## 中西區區內不合標準和缺乏連接的行人路

17 December 2014

## **Missing and sub-standard pedestrian connections in the Central & Western District**

2.

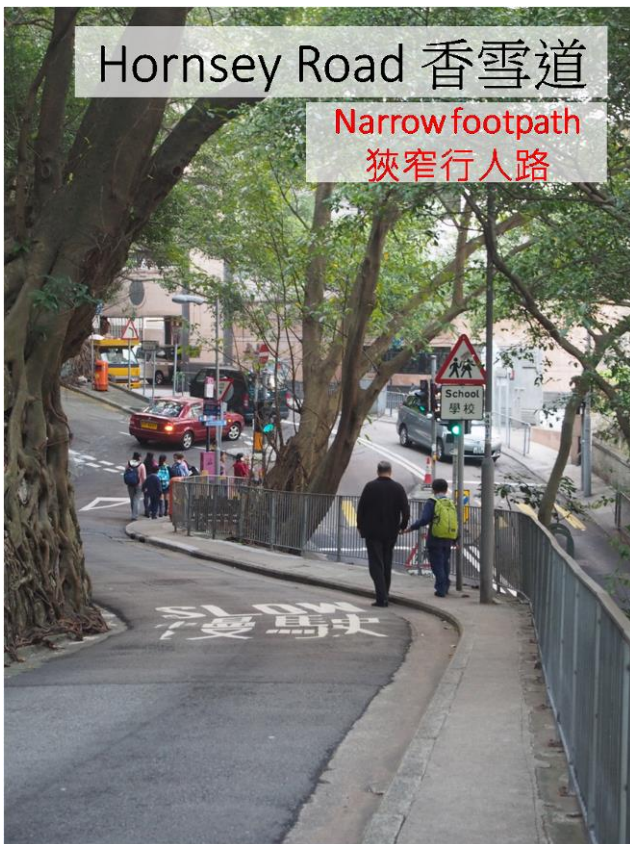
Location: Junction of Bonham Road, Caine Road, Hospital Road and Seymour Road  
Problem: Unsafe Crossing  
Description: Unsafe crossing at a junction of three lanes  
Suggestion: Provide a zebra and/or signalised crossing

位置: 般咸道、堅道、醫院道與西摩道交界  
問題: 過路處不安全  
詳情: 過路處於路口交界處，不安全  
建議: 提供斑馬綫和/或交通燈控制的過路處

4.

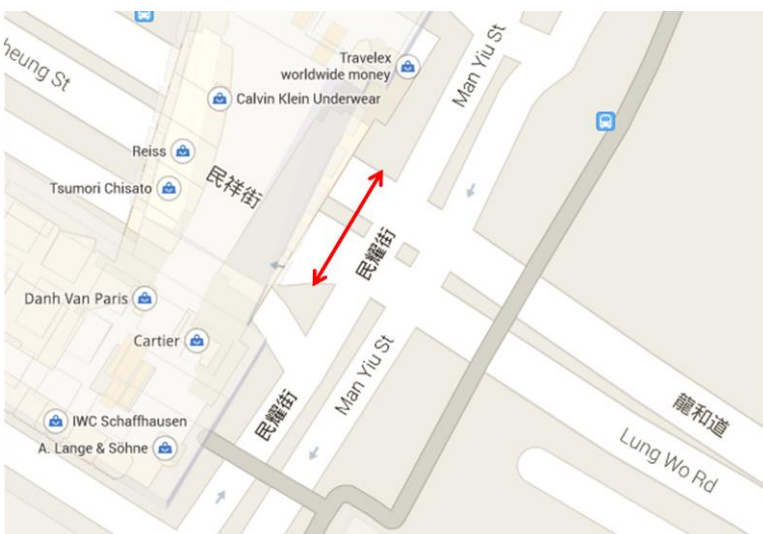
Location: Man Cheung Street  
Problem: Missing Crossing  
Description: Missing crossing to connect both sides of footpath and lack of barrier-free access  
Suggestion: Provide zebra crossing at the indicated location, dropped kerb and pedestrian signals on both sides

位置: 民祥街  
問題: 缺乏過路處  
詳情: 缺乏過路處連接兩旁行人路及無障礙通道  
建議: 於箭咀位置提供斑馬綫，並增設下斜路緣及行人過路燈號於兩旁

5.

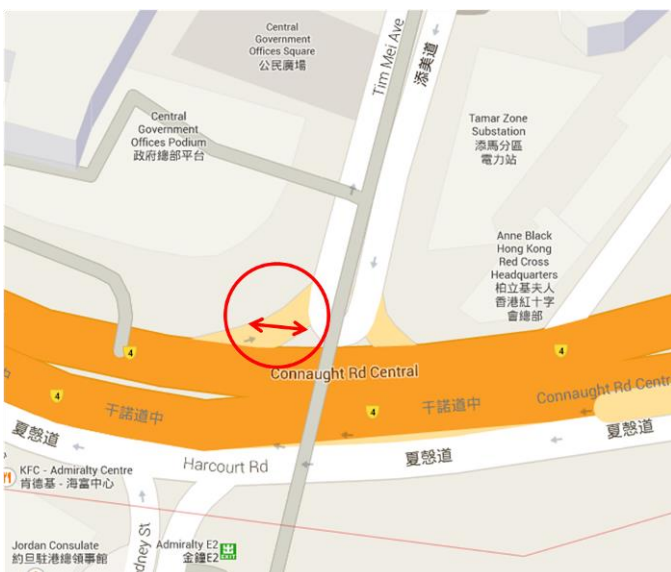
Location: Justice Drive  
Problem: Unsafe crossing  
Description: Limiting sightline for pedestrians  
Suggestion: Provide a zebra and/or signalised crossing

位置: 正義道  
問題: 過路處不安全  
詳情: 行人視線受限制  
建議: 提供斑馬綫和/或交通燈控制的過路處
